**Minutes of the Meeting
May 21, 1998**

Projects Reviewed

Downtown Circulation Study
East Pine Street Substation
West Galer Street Flyover
Alaskan Way Trees
African American Academy
WSCTC Expansion (streetscape briefing)

Plan/Section of Viewing Tower

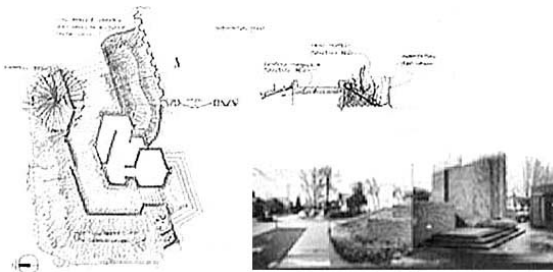
- Dubrow:** There may be ways to make the addition and the tower projects work together in terms of materials by recycling brick from the tower for the addition. The Phase 3 projects, playground and public open space, should be discussed in conjunction with the viewing tower project.

- Dubrow:** Taking space for yard expansion, while replacing the tower with more public amenities, such as a playground, may do both.
- Sundberg:** The original usefulness for the tower seems to be gone now.

- Dubrow:** It is important to make a civic gesture in replacing the tower.
- Sundberg:** The original intent of the tower was to give the public visual access to the yard. The corner projects should then be considered holistically in terms of meeting this intent of visual public access to the facility.

- Larsen:** It is important to educate the public in the facility activities.
- Foley:** If the tower is retained, it should remain separate from the wall structure. I like its legibility as a separate element.

- Larsen:** We can instigate the option of sloping the soil between the tower and the wall, with thorny plantings, if an escalated, immediate need to deal with security issues arises.

- Swift:** That sounds like a sound strategy. In terms of a more permanent solution, I urge that you invest the money necessary to gate it in a manner that fits with the structure's appearance. People interpret a chain link system as a lack of investment.

The Commission also looks forward to seeing further development of alternatives for the viewing tower with consideration of the original intent of providing a public amenity and the opportunity to provide visual public access to the yard.

Floor Plan and North Elevation

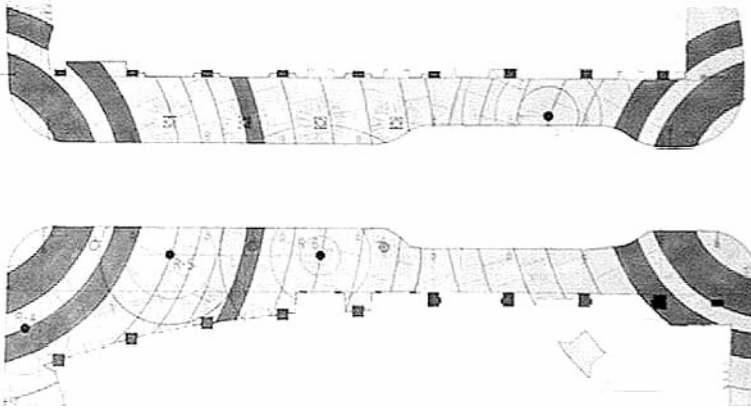
- Dubrow:** My sense is that there is a lot of public benefit in the building with the community spaces, computer labs, play fields, and auditorium. It is difficult to comment on the street vacations without a plan showing the streets and ROW's to be vacated.. I appreciate the layout of the building and the environmental layout of the wetlands. However, I am having difficulty in evaluating the building's contextual fit without any information on the larger context.

- Dubrow:** It is unusual to see a building of this size set at an angle to the main street. Most old school buildings have a dominant street presence in the neighborhood by facing parallel to the street. The street presence of this school may need to be enhanced.

- Action:** **The Commission has determined that this project constitutes a clear public benefit and therefore recommends approval of the street vacations.**

Lantern atop vertical sculptures

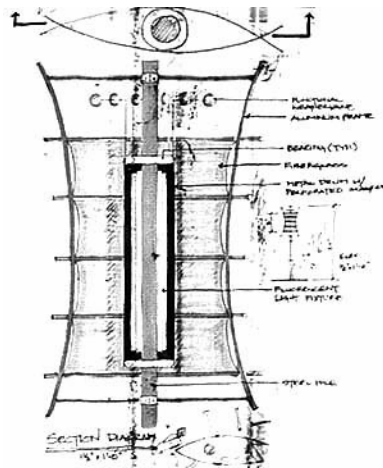
- Dubrow:** Why can't it extend into the curb?
- Nelson:** Because the curbs are owned and maintained by the City.
- Dubrow:** Why is new design for the vertical sculpture elements so much more restrained than the last version?

- Law:** It is only another conceptual starting point for the artists. I will be sure to get any comments you have back to them.
- Dubrow:** Without understanding the motive for the drastic conceptual change, I wonder about the muted colors and form. There is so much geometric patterning on the ground plane, I am a little disappointed at the lack of exuberance in the sculptures.

- **reconsider the issue of vitality and spatial presence of the sculpture columns, both in color and form;**
- **the Commission would like to see a relaxation of the determination regarding the width of a safety zone between the street and seating areas and does not believe there is a need to install bollards along the curb;**
- **given the goal of creating a pedestrian oriented space not dominated by vehicles, the Commission would like a briefing on the determination regarding the safety zone and location of public seating,;**
- **if traffic is a concern, investigate traffic calming devices that are consistent with the design principles identified for the project.**
